RE: Eastshore Energy, LLC Preliminary Staff Assessment Comments  
Eastshore Energy Center (06-AFC-6)

Listed below, for CEC staff's consideration, are Eastshore Energy, LLC's comments on the Preliminary Staff Assessment (PSA) for the Eastshore Energy Center (Eastshore) project (06-AFC-06).

ORDER	
SUPV.	
DSGN.	B&V/SSB
DWN.	B&V/SSB
CHKD.	B&V/EPC
O.K.	
DATE	SCALE
07/01/07	1" : 200'

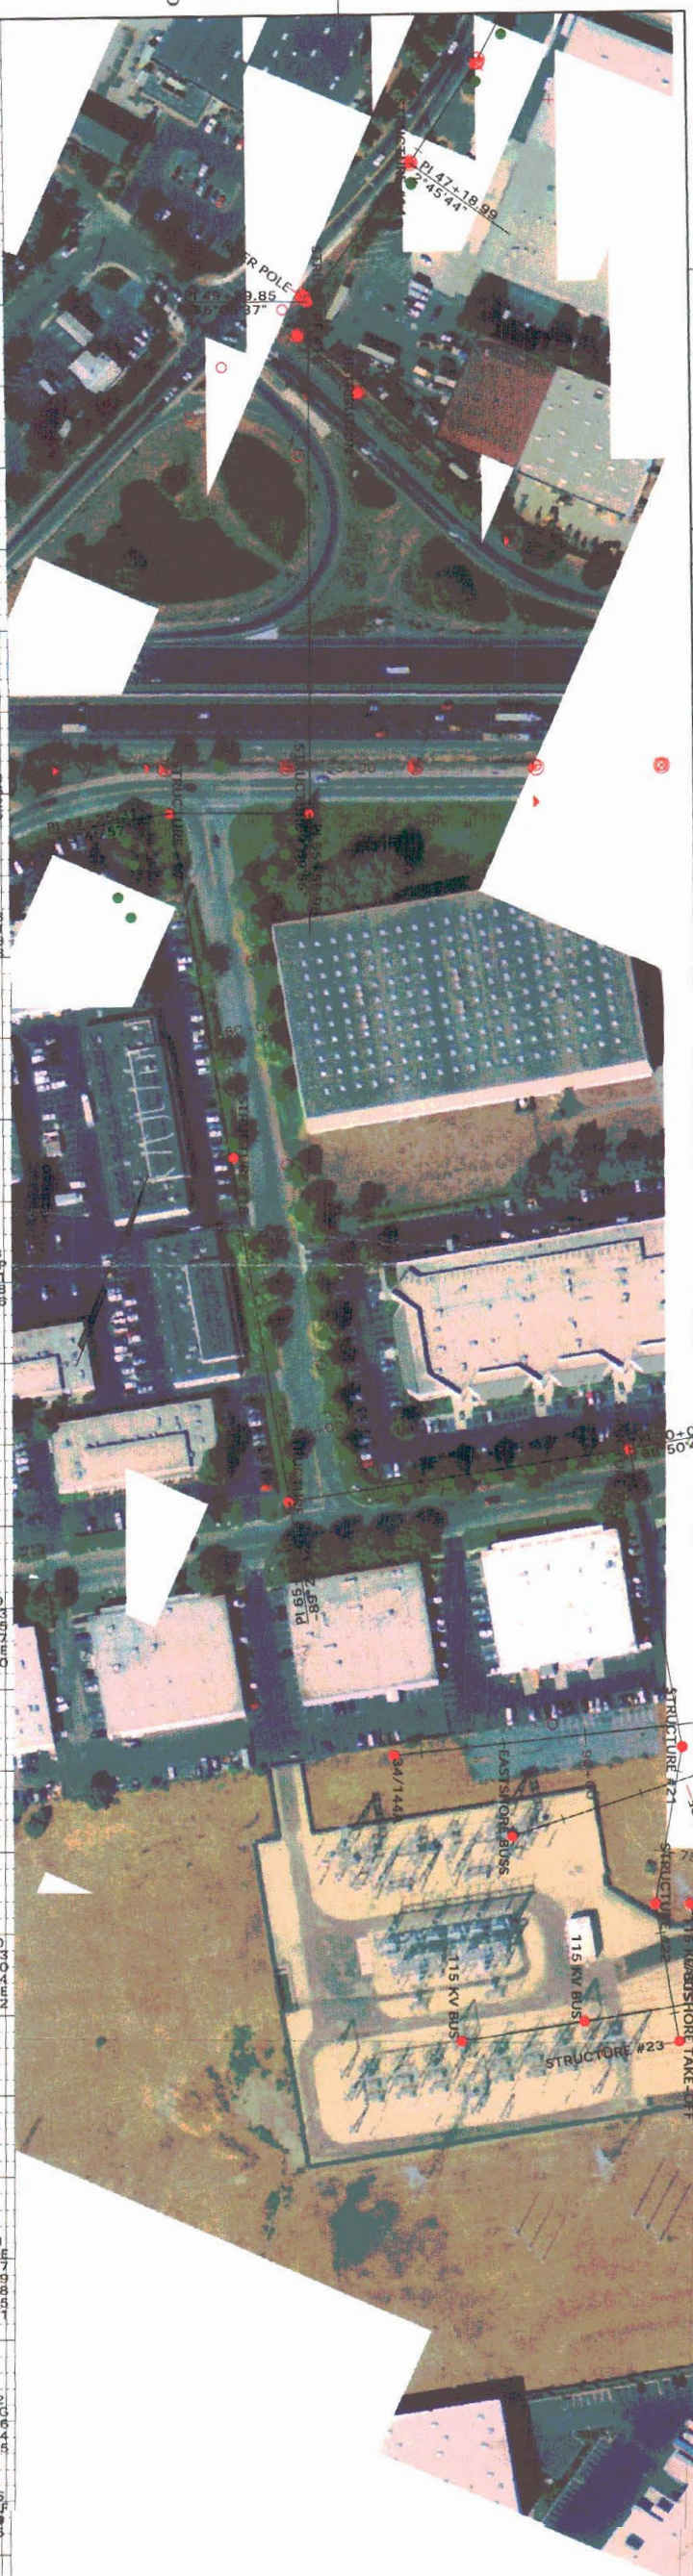
Page 4.2-9, under the discussion of "Sensitive Habitats", 2<sup>nd</sup> paragraph Attachment BIO-1 includes recent information from PG&E regarding the preliminary locations of transmission poles and structures that demonstrate the transmission line construction will not impact identified wetlands or burrowing owl habitat and should adequately address Staff's concern. However, if necessary, Eastshore would agree to a COC that requires that the transmission line not cross or otherwise impact identified wetlands on Eastshore substation property or burrowing owl habitat.

Page 5.5-1, regarding the sentence that reads, "PG&E transmission system... require analysis by PG&E and approval by California ISO", PG&E has completed the design of the 1.2 mile tie line as of mid-August, 2007 and all the structures and the route has been finalized. Please refer to Attachment BIO-1.

Page 5.5-4, under the discussion of "Project Description", please correct this discussion as follows: 80-foot pole structures will support the 115 kV transmission lines, the 85-foot pole structures will support the 115 kV transmission lines with 12 kV distribution lines, and a 90-foot pole structure will be placed on the south side and 60-foot on the north side of Highway 92. This information is based on the design of the 1.2 mile tie-line completed by PG&E as of mid-August 2007. Please refer to Attachment Bio-1.
